# Department of Environmental Quality

May 28, 2010

RE: TFN 4 6/268, Clarification of comments discussed during May 6, 2010 meeting, Mine Unit 1, Second Round of Review Comments

**SILT FENCE**

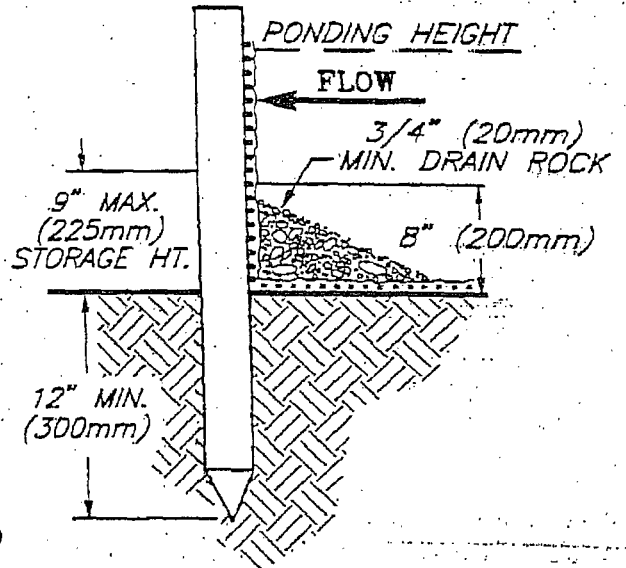
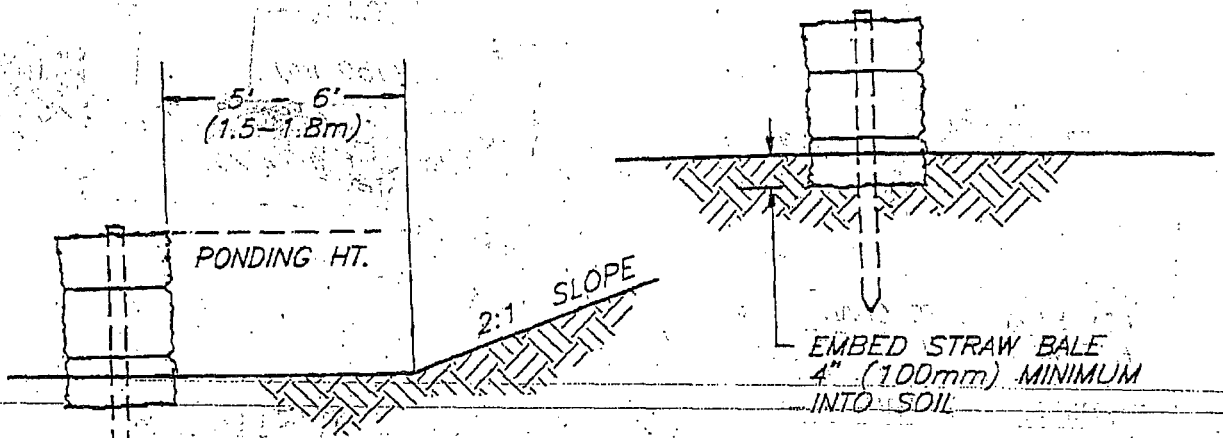
There will be areas where maintaining adequate vegetative buffer strip may not be adequate, thus, some form of sediment control will be required. Lost Creek ISR does not propose to construct any type of retention pond rather Alternate Sediment Control Measures (ASCM's), as described in the WDEQ/LQD Guideline 15, will be utilized. ASCM's anticipated to be utilized include silt fence, various types of check dams, small berms/diversions to capture or intercept and divert overland flow toward a structure (e.g., a porous rock check dam) for treatment. In some instances, depending on the areal extent of contributing

drainage area, Lost Creek, ISR may utilize ASCM's in series in order to provide adequate sediment control. Generic designs for various ASCM's are presented in Attachment OP-4A.

At a minimum Lost Creek ISR will inspect all ASCM's at the beginning of the runoff season (March 1 to November 1) and after each runoff event. Through the runoff season, ASCM's will be inspected at least once a month. An inspection and maintenance log will be kept to document the condition of each ASCM at the time of each inspection. Lost Creek ISR log and repair any significant damage to an ASCM as soon as possible after it occurs. The Stormwater Permit issued by WDEQ/WQD can be found in the **Adjudication Section, Attachment ADJ-3** and as a permit requirement a Stormwater Pollution Prevention Plan has been developed and will be on file at the Mine Office. The plan contains provisions for evaluating construction impacts and unanticipated impacts, such as spills. Provisions for spill detection and response are also addressed in **Section OP 2.9**.
